E8362B-02A

**S E R V I C E N O T E**

E8362B PNA Microwave Network Analyzers

**Figure 1:** A3 Front Panel Interface Board Assy without the Bracket

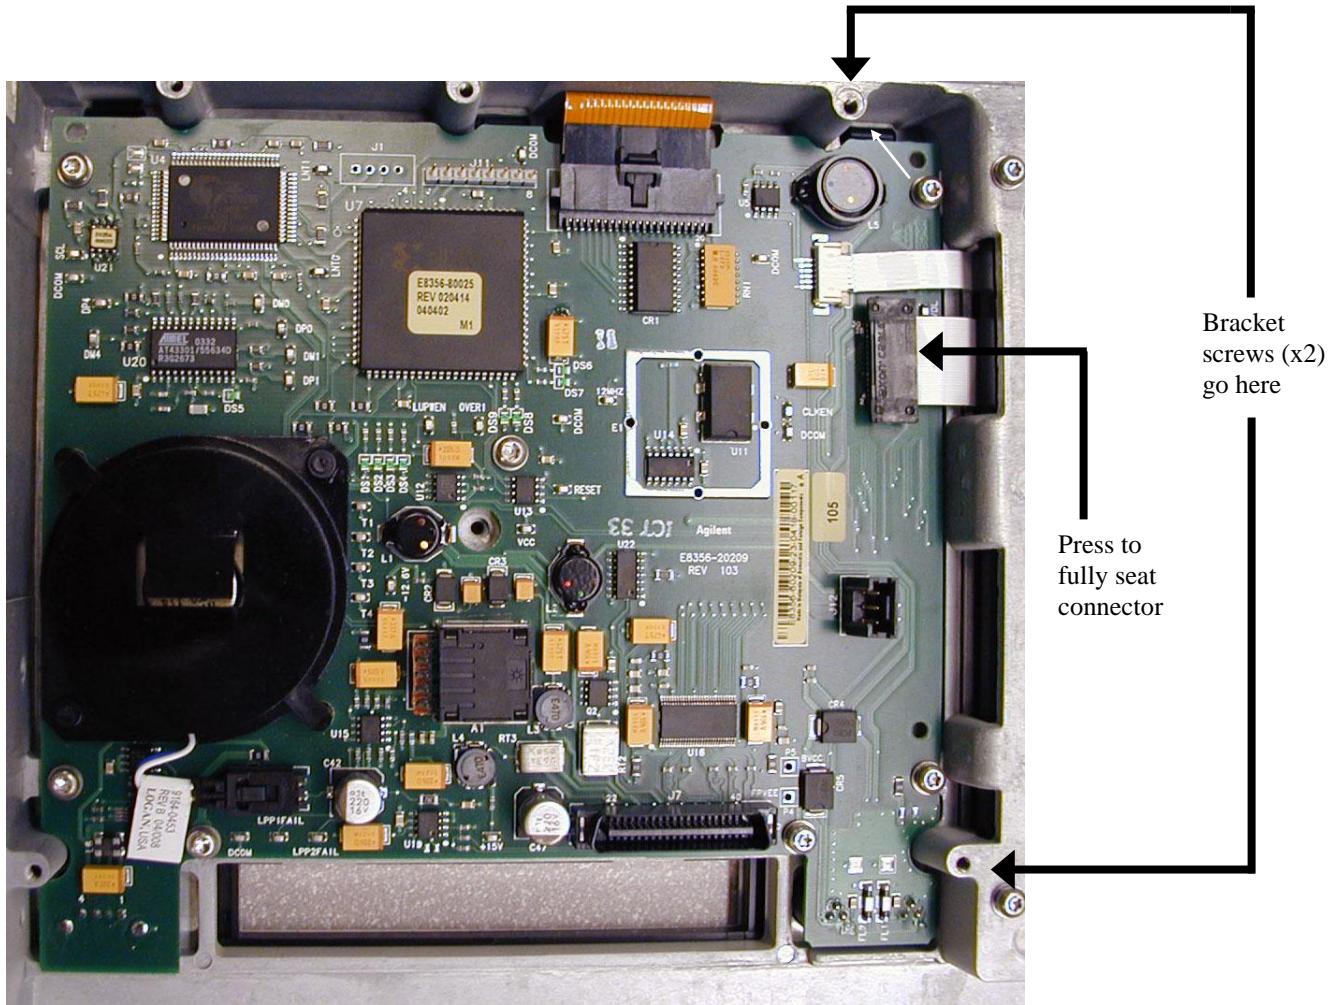
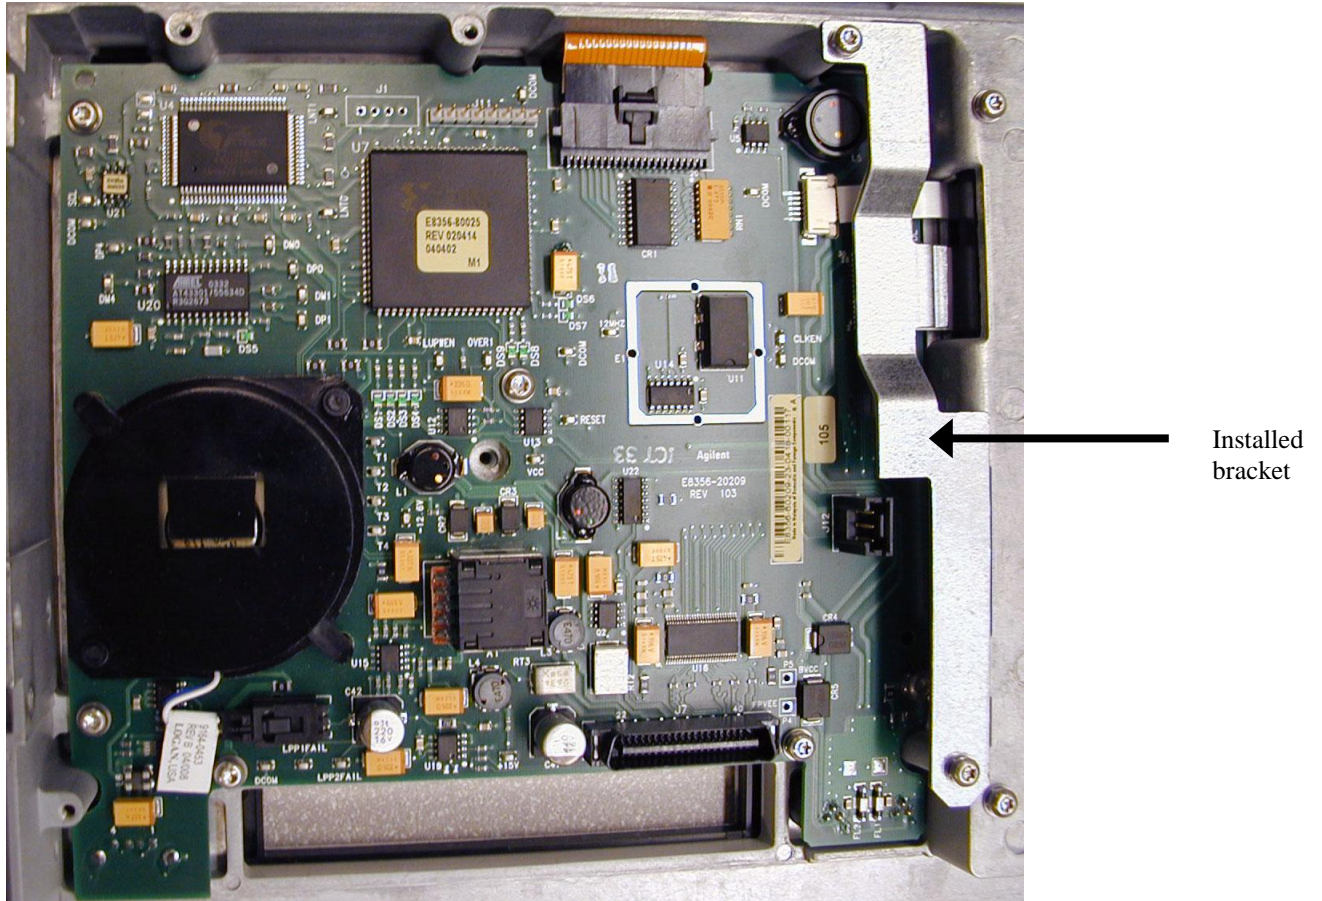
A connector of the ribbon cable (Agilent part number 8120-8409) that joins the front panel display to the front panel interface board can loosen, causing a display failure, unless a new bracket is installed. Because the failure rate has been very low, it is recommended that the bracket be installed only when there is an additional reason to remove the PNA front panel.

1. Refer to Figure 1 in this document:
  - Press down firmly on the ribbon cable's black connector.
  - Locate the two tapped holes for the bracket screws.
2. As shown in Figure 2 in this document, position the bracket so that its holes line-up with the two holes you located in the previous step.
3. Hand-start the two screws, and then torque both to 9 in-lbs.
4. Reinstall the PNA Front Panel by following the Service Guide instructions in the "Replacement Procedure." This is located on the same page as the "Removal Procedure" used previously in step 7.
